Change Order #2
Taylor Road

Project: Taylor Road
Project #: 25-367-05-29
Contract: 25-367-05-29
CSJ: 0921-02-328
Limits: Business 83 to Mile 2(Daffodil Road)

CONSTRUCTION CONTRACT CHANGE ORDER NUMBER: 2

5. New or revised plan sheet(s) are attached and numbered: 49A, 64A, 201A, 202A, 203A, 204A, 220A, 225A, 235A

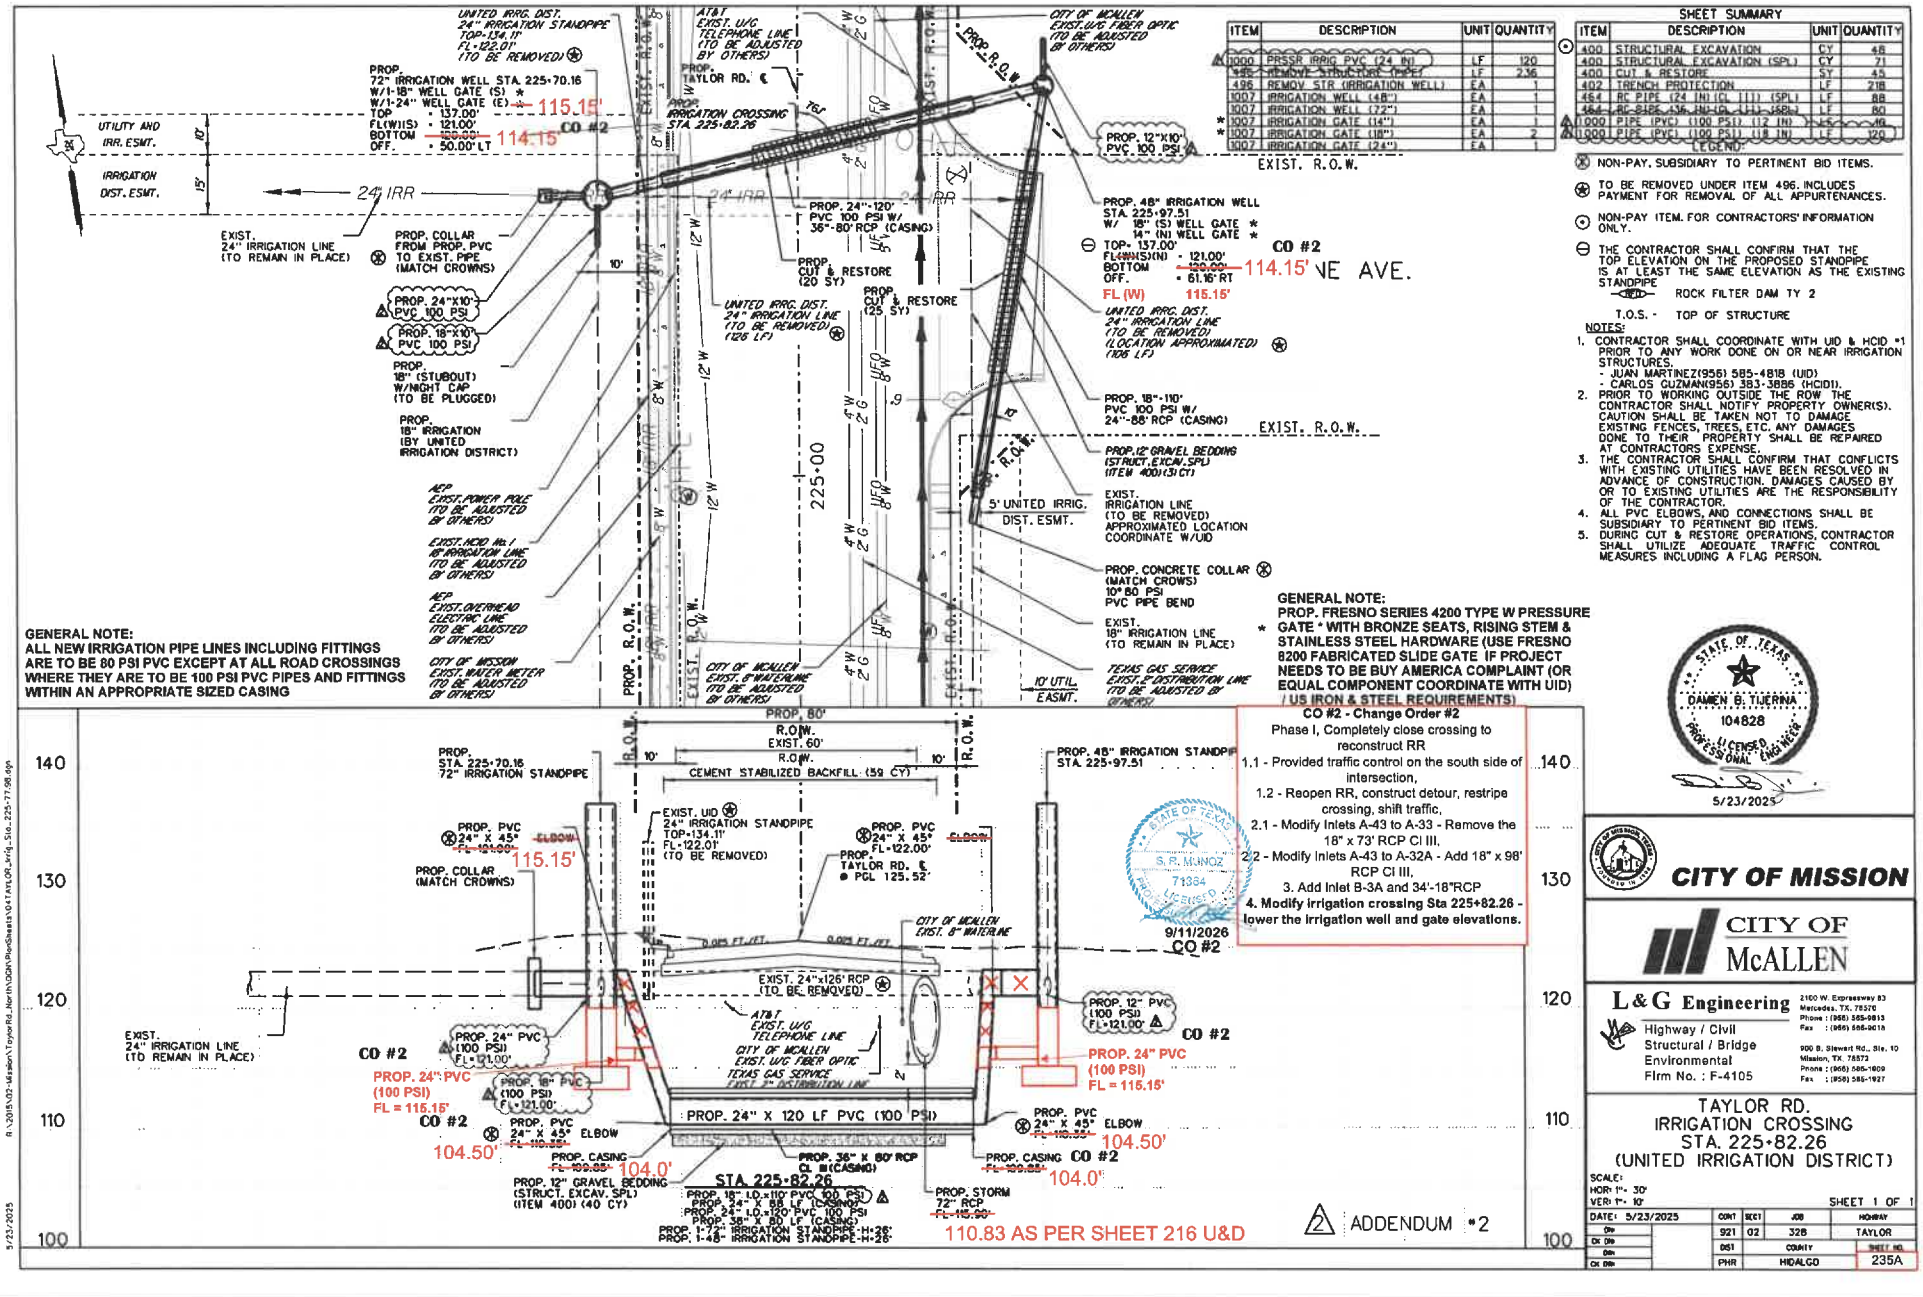
115.15'
114.15
CO #2
UTILITY AND IRR. ESMT.
IRRIGATION DIST. ESMT.
24" IRR
EXIST. 24" IRRIGATION LINE (TO REMAIN IN PLACE)
PROP. COLLAR FROM PROP. PVC TO EXIST. PIPE (MATCH CROWNS)
PROP. 24"X10" PVC 100 PSI
PROP. 18"X10" PVC 100 PSI
PROP. 18" (STUBOUT) W/HGHT CAP (TO BE PLUGGED)
PROP. 18" IRRIGATION (BY UNITED IRRIGATION DISTRICT)
AEP EXIST. POWER POLE (TO BE ADJUSTED BY OTHERS)
EXIST. MCID No.1 18" IRRIGATION LINE (TO BE ADJUSTED BY OTHERS)
AEP EXIST. OVERHEAD ELECTRIC LINE (TO BE ADJUSTED BY OTHERS)
CITY OF MISSION EXIST. WATER METER (TO BE ADJUSTED BY OTHERS)
AT&T EXIST. U/G TELEPHONE LINE (TO BE ADJUSTED BY OTHERS)
PROP. TAYLOR RD. ℄
PROP. IRRIGATION CROSSING STA. 225+82.26
CITY OF MCALLEN EXIST. U/G FIBER OPTIC (TO BE ADJUSTED BY OTHERS)
PROP. R.O.W.
EXIST. R.O.W.
PROP. 12"X10" PVC 100 PSI
PROP. 24"-120° PVC 100 PSI W/ 36"-80° RCP (CASING)
PROP. CUT & RESTORE (20 SY)
PROP. CUT & RESTORE (25 SY)
UNITED IRRG. DIST. 24" IRRIGATION LINE (TO BE REMOVED) (126 LF)

UNITED IRRG. DIST. 24" IRRIGATION LINE (TO BE REMOVED) (LOCATION APPROXIMATED) (106 LF)
PROP. 48" IRRIGATION WELL STA. 225+97.51 W/ 18" (S) WELL GATE * 14" (N) WELL GATE *
TOP- 137.00'
FL(W)(S)(N) - 121.00'
BOTTOM - 120.00'
OFF. - 61.16' RT
FL (W) 115.15'
CO #2

DIST.	STATE	PROJECT NO.				HIGHWAY NO.
6	TX					TAYLOR
DIST.	COUNTY	CONTROL NO.	SECTION NO.	JOB NO.	SHEET NO.	
PHR	HIDALGO	0921	02	328	220A

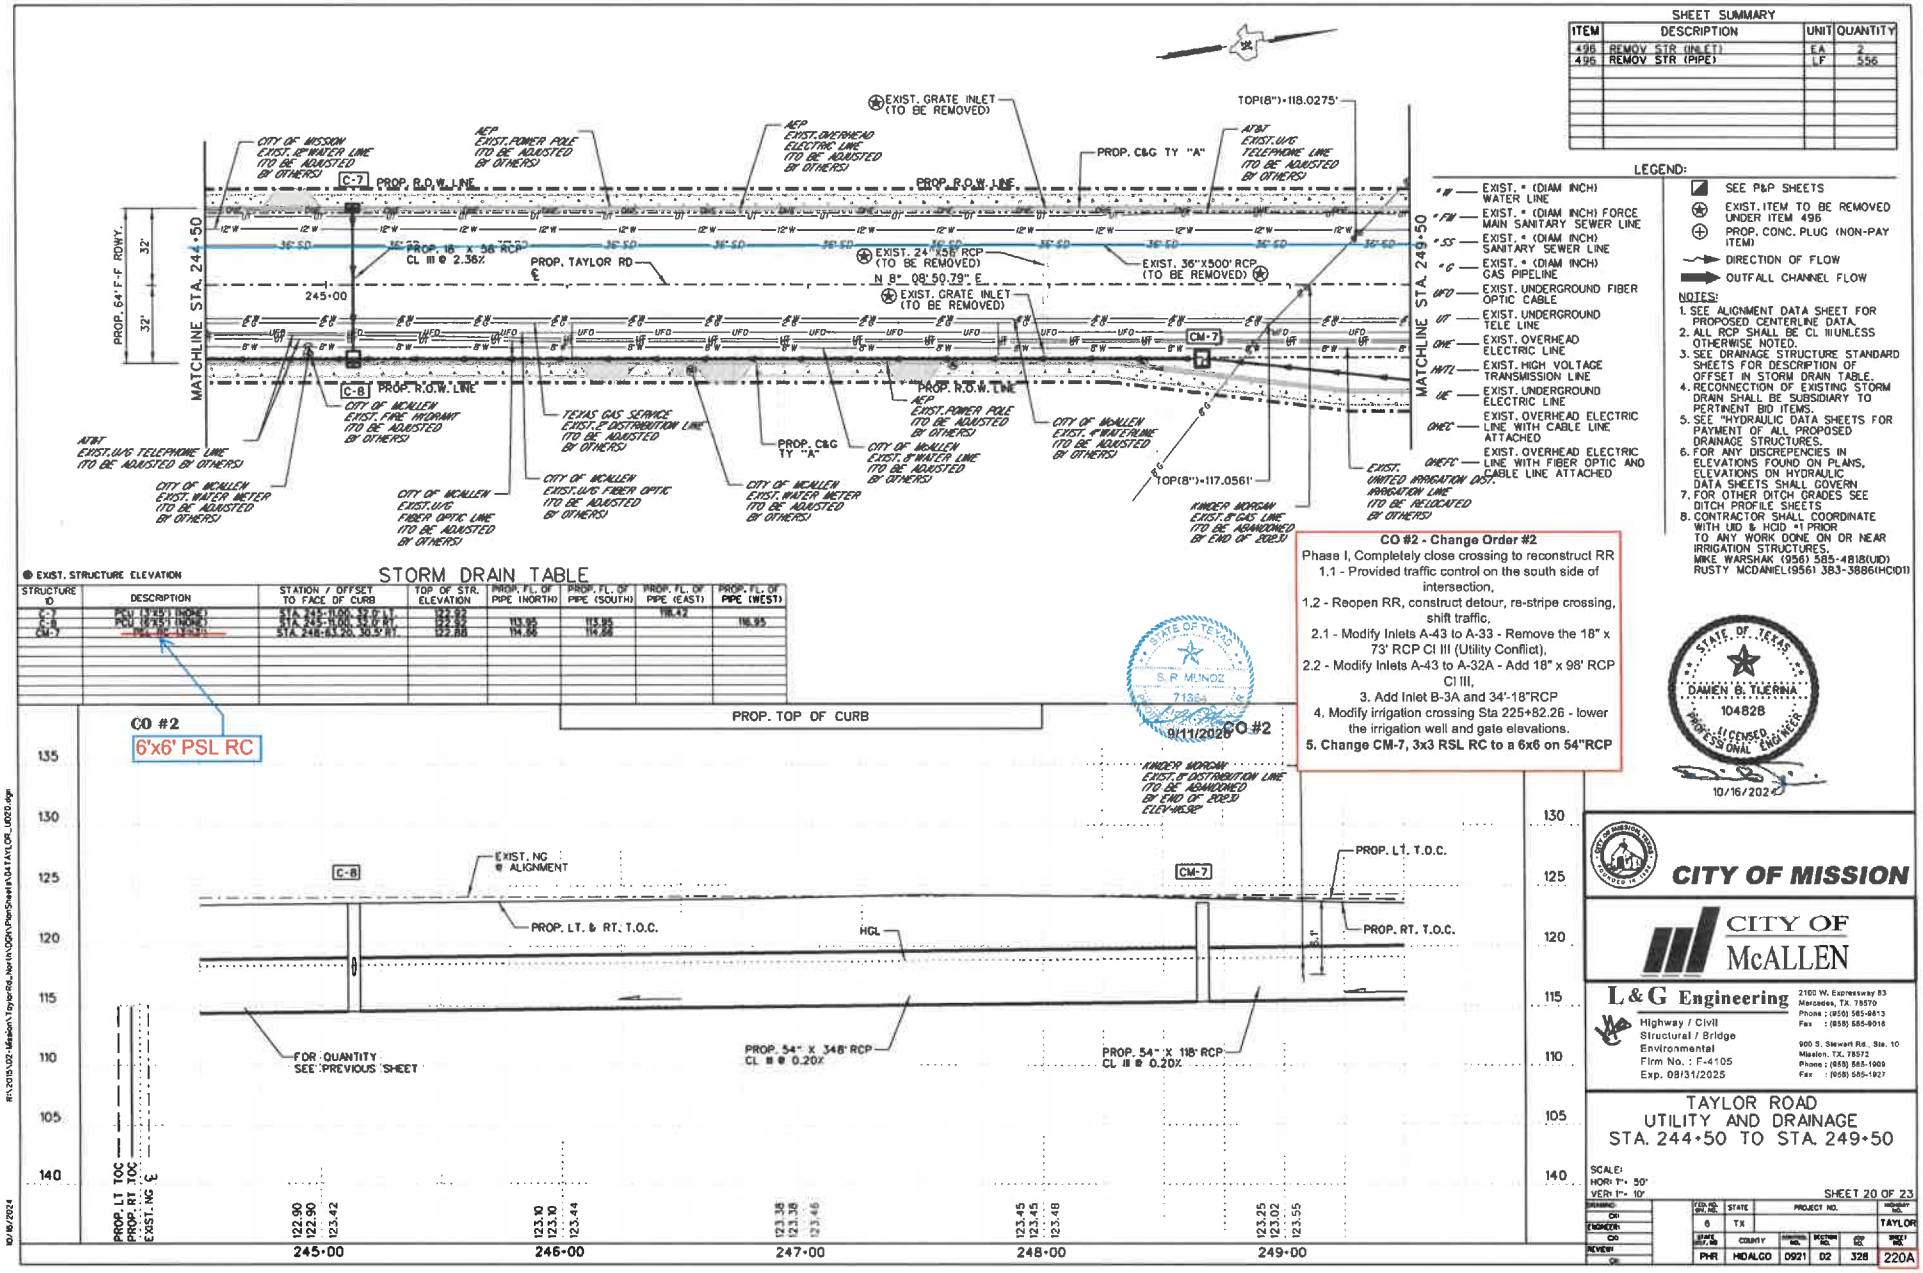
Phase I, Completely close crossing to reconstruct RR
1.1 - Provided traffic control on the south side of intersection,
1.2 - Reopen RR, construct detour, re-stripe crossing, shift traffic,
2.1 - Modify Inlets A-43 to A-33 - Remove the 18" x 73' RCP Cl III (Utility Conflict),
2.2 - Modify Inlets A-43 to A-32A - Add 18" x 98' RCP Cl III,
3. Add Inlet B-3A and 34'-18"RCP
4. Modify irrigation crossing Sta 225+82.26 - lower the irrigation well and gate elevations.
5. Change CM-7, 3x3 RSL RC to a 6x6 on 54"RCP
